[Docket No. 2003-CE-43-AD; Amendment 39-13328; AD 2003-20-10]

Airworthiness Directives; Raytheon Aircraft Company Beech Models 1900, 1900C, and 1900D Airplanes

2003-20-10 Raytheon Aircraft Company:
Amendment 39-13328; Docket No. 2003-CE-43-AD.

Figure 1

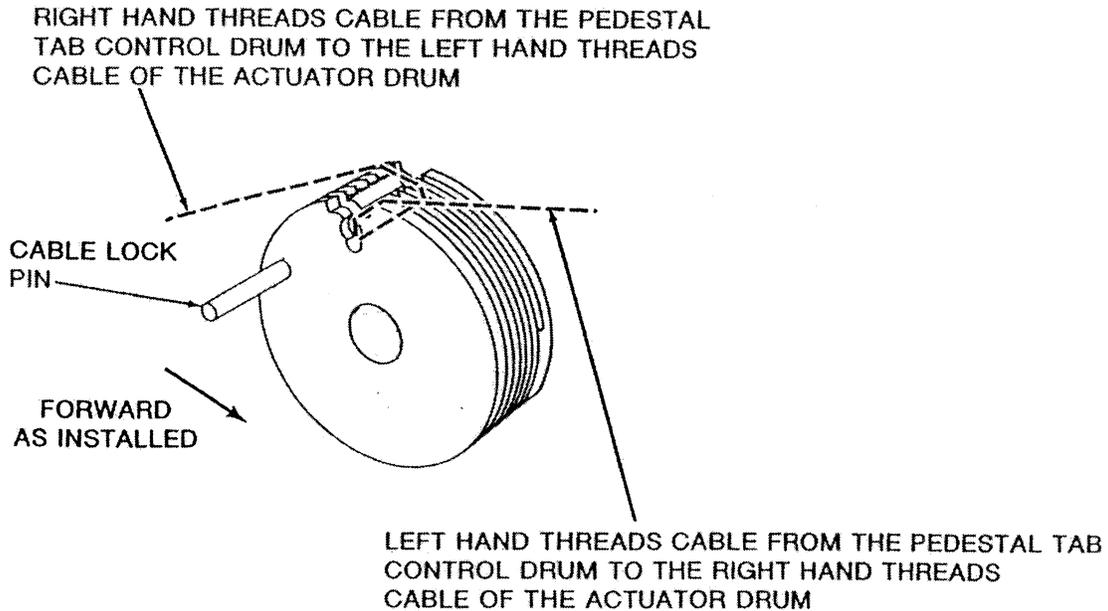
- The figures in the applicable maintenance manuals depict the elevator trim cable drum at 180 degrees from the installed position and show the open, keyed side of the drum instead of the flat side of the drum. Following these figures when installing the control cables on the forward control cable drum could reverse the action of the elevator manual trim system; and
- The existing procedure can be enhanced by visually confirming the trim wheel position and the trim tab position are consistent. Such a check would detect and correct any problems with the elevator trim system installation before problems occur during operation.

Although the figures (figure 9 for the 1900/1900C and figure 201 for the 1900D) in the existing maintenance manuals are incorrectly depicted, following the step-by-step written instructions in the existing procedure and referring to the orientation of the parts removed would result in the correct installation and action of the elevator trim system.

Actions	Compliance	Procedures
<p>(1) Using pen and ink, mark the applicable figure in the maintenance manual as referenced below. The depiction in the referenced figures is incorrect for the elevator trim drum only and depicts the cable drum at 180 degrees from the installed position and shows the open, keyed side of the drum instead of the flat side of the drum. Insert corrected figure (Figure 1 of this AD) into the applicable maintenance manual and identify it accordingly:</p> <ul style="list-style-type: none"> (i) Figure 9 of Chapter 27-10-00 of the Model 1900/1900C Airliner Maintenance Manual (114-590021-7B) Clearly note in pen that existing portion of Figure 9 is correct for the aileron trim drum only and insert corrected figure (Figure 1 of this AD) marked in pen as correct for the elevator trim drum only; or 	<p>Before the next time you have maintenance done on the elevator trim system.</p>	<p>As specified in Raytheon Safety Communiqué No. 234, dated September 2003.</p>

Actions	Compliance	Procedures
<p>(ii) Mark out Figure 201 of Chapter 27-30-04 of the Model 1900D Airliner Maintenance Manual (125-590000-15). Insert corrected figure (Figure 1 of this AD)</p> <p>(2) Incorporate the applicable temporary revision into the maintenance manuals as follows:</p> <p>(i) Temporary Revision No. 27-5 to the Model 1900/1900C Airliner Maintenance Manual: Revised ELEVATOR TRIM OPERATIONAL CHECK; or</p> <p>(ii) Temporary Revision No. 27-9 to the Model 1900D Airliner Maintenance Manual: Added MANUAL ELEVATOR TRIM OPERATIONAL CHECK.</p> <p>(3) Do the elevator trim operational check that is specified in the applicable maintenance manual and temporary revisions to the maintenance manual as referenced in paragraph (e)(2) of this AD</p>	<p>Before the next time you have maintenance done on the elevator trim system.</p> <p>Prior to further flight after each time you have maintenance done on the elevator trim system.</p>	<p>As specified in Raytheon Safety Communiqué No. 234, dated September 2003.</p> <p>As specified in Raytheon Safety Communiqué No. 234, dated September 2003; and Temporary Revision No. 27-5 to the Model 1900/1900C Airliner Maintenance Manual: Revised ELEVATOR TRIM OPERATIONAL CHECK; or Temporary Revision No. 27-9 to the Model 1900D Airliner Maintenance Manual: Added MANUAL ELEVATOR TRIM OPERATIONAL CHECK, both dated September 12, 2003, as applicable.</p>
